**APPENDIX 1 : PLAN CHANGE 4
AS AMENDED BY RECOMMENDATIONS**

Queenstown Lakes District Council

Proposed Plan Change 4

North Three Parks

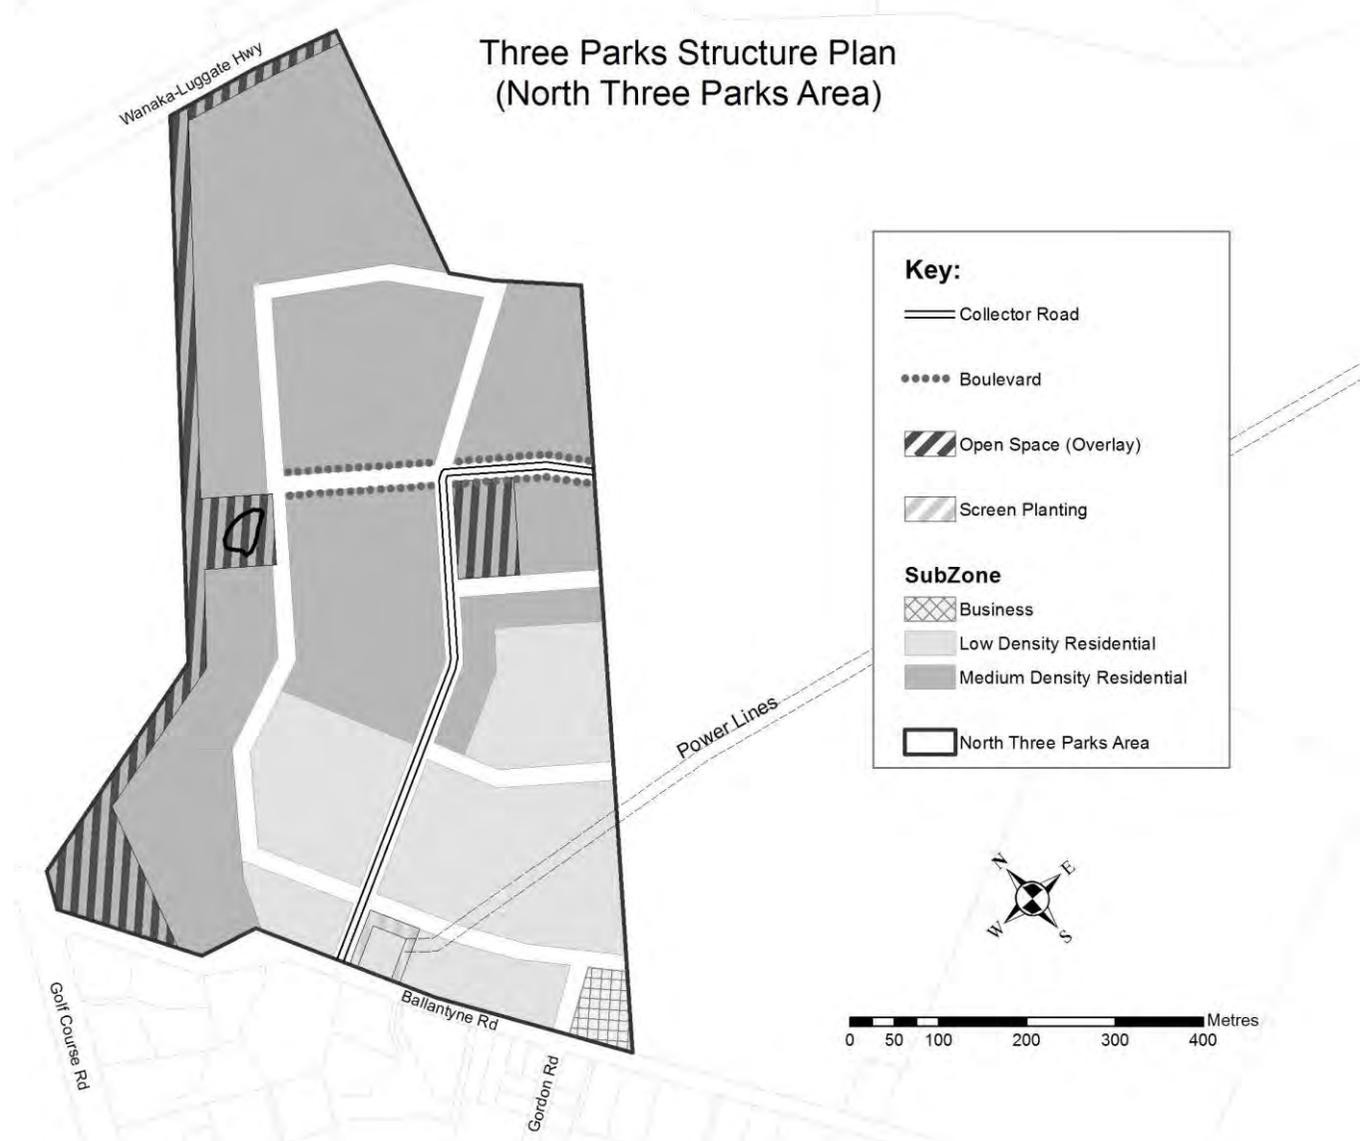
- I. An additional area of land (North Three Parks) to be zoned as the Three Parks Zone on Planning Map 21.

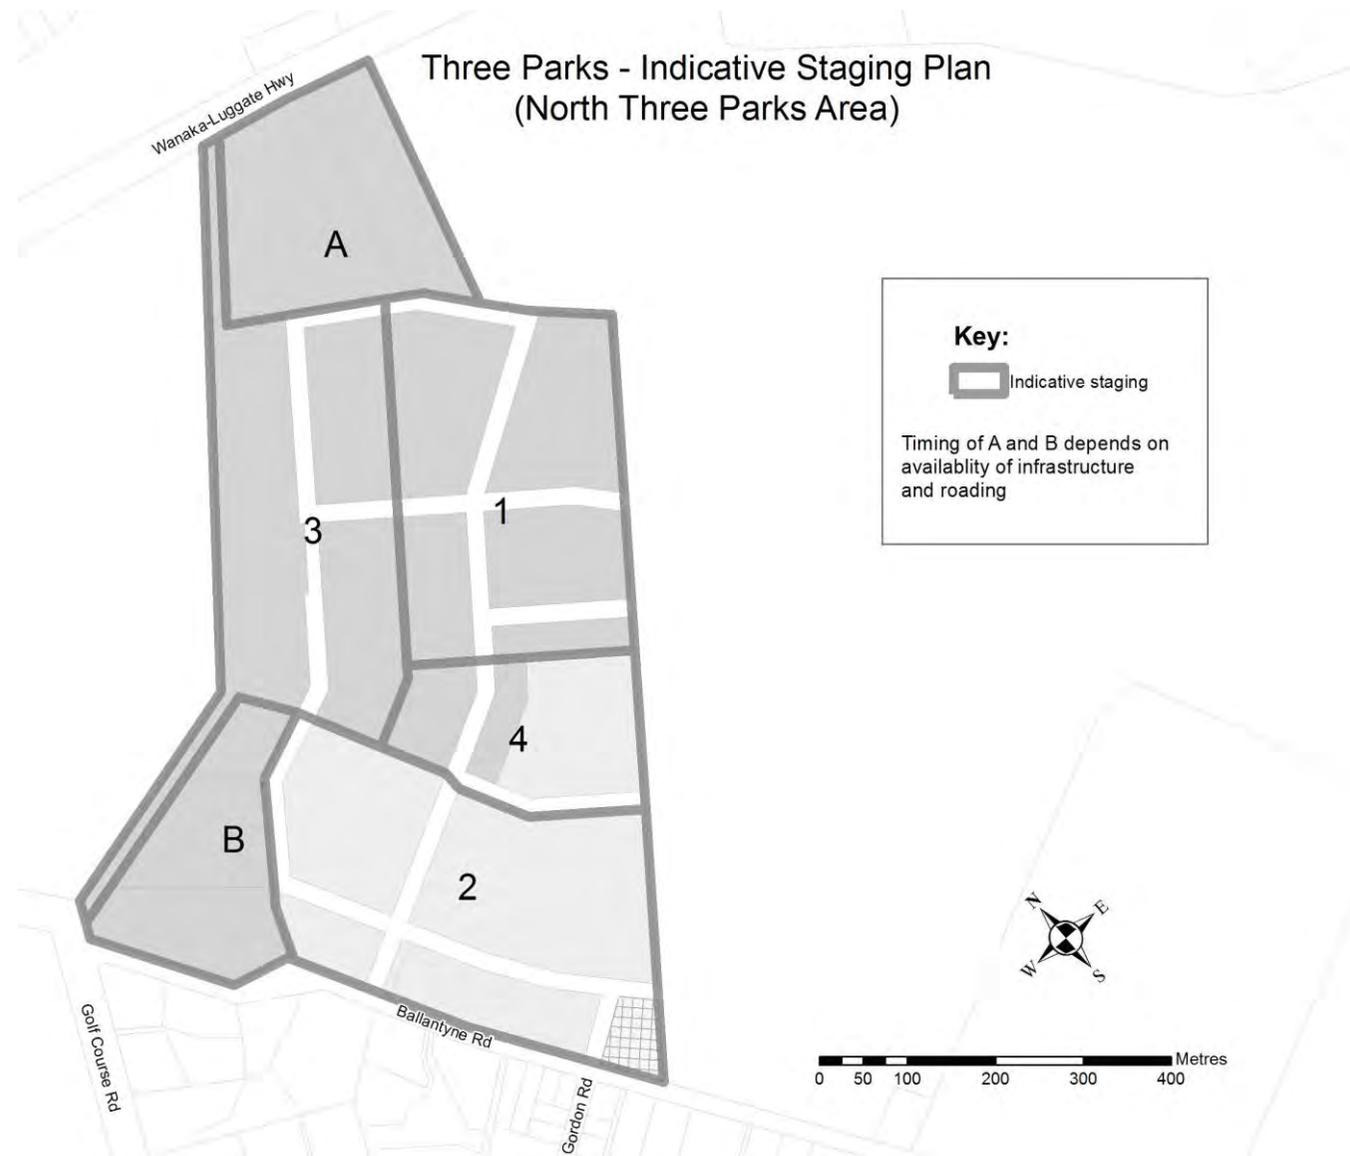
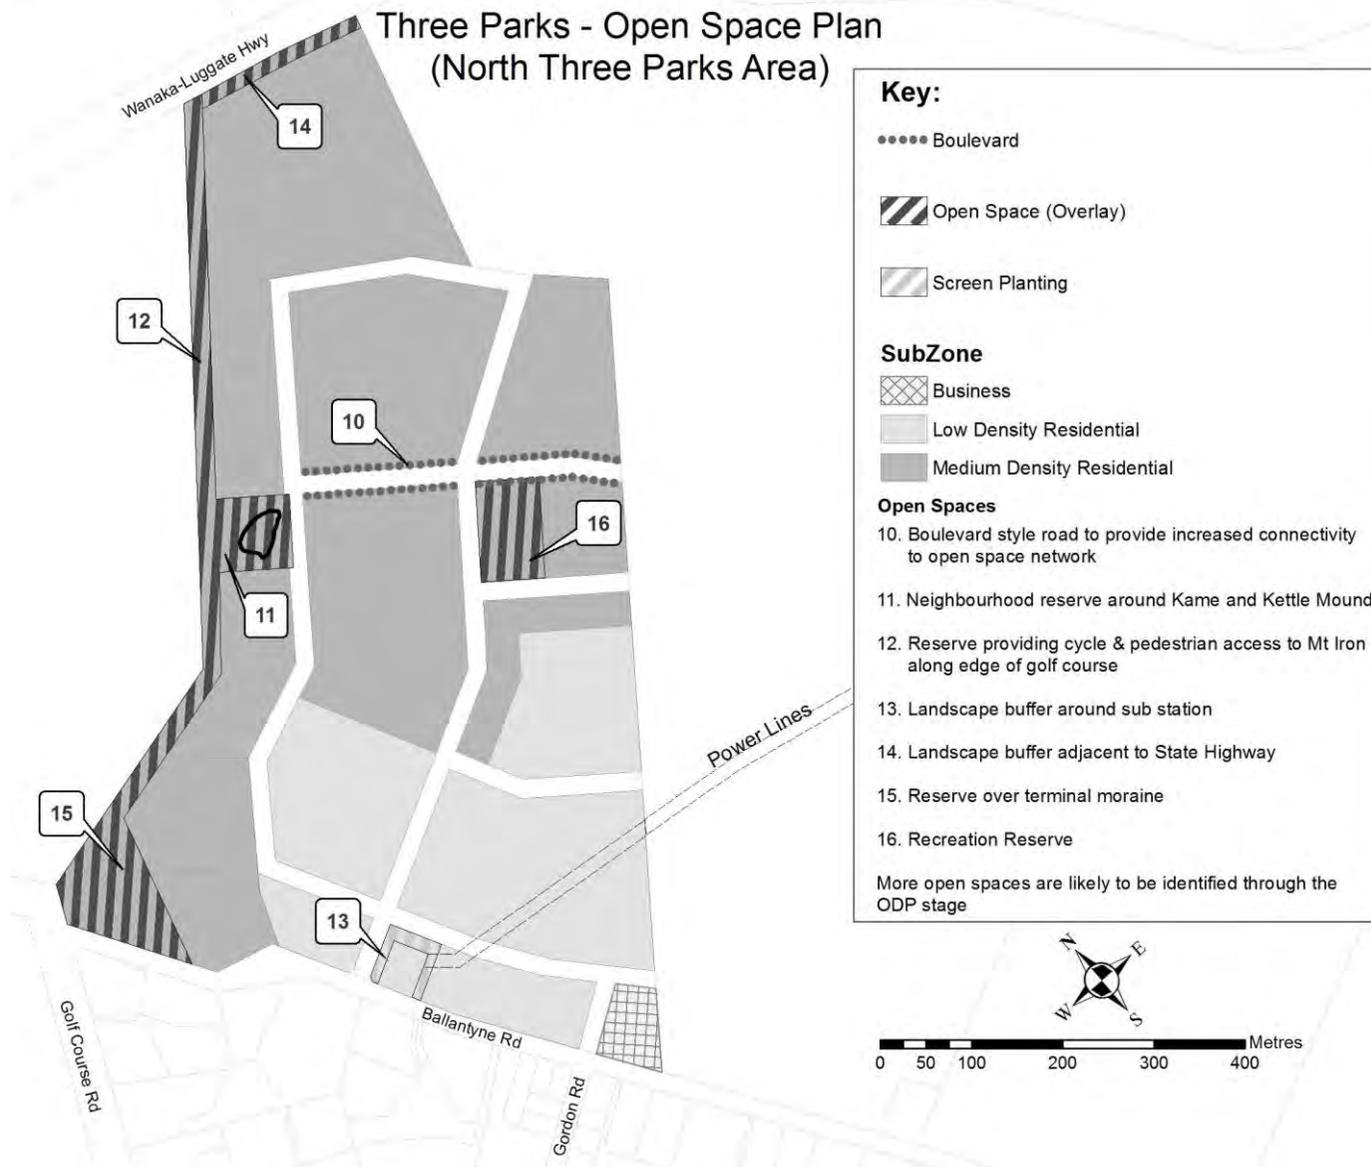
- (b) An additional area of land (North Three Parks Area) to the Three Parks Zone by adding this area of land to Section 12.25.3 Three Parks Structure Plan, Three Parks - Indicative Staging Plan and Three Parks - Open Space Plan as follows:

Indicative layout for residential land use abutting the linear park by the golf course in the North Three Parks Area.

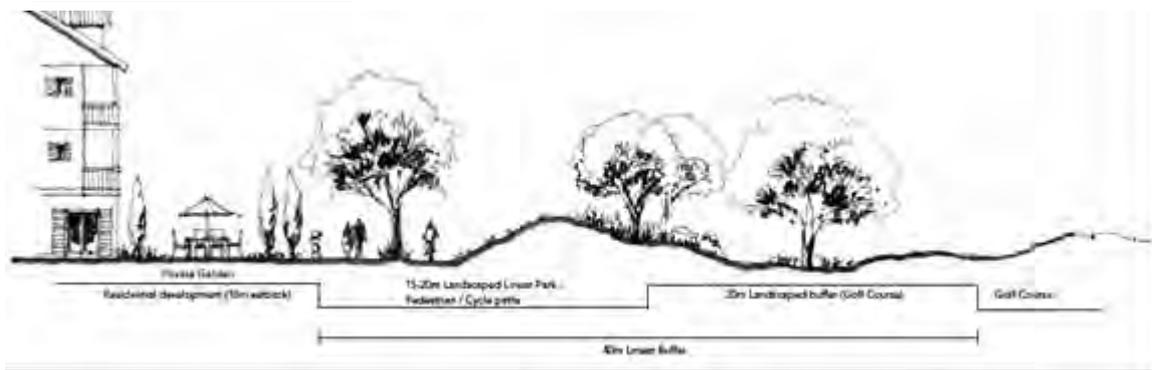
- (i) An additional diagram, heading and amended Note to follow Assessment Matter 12.26.4.5ii(p) showing another option for an acceptable relationship between residential land use and open space where Medium Density Residential abuts the linear park adjacent to the golf course as shown in the North Three Parks Urban Design Framework as follows:
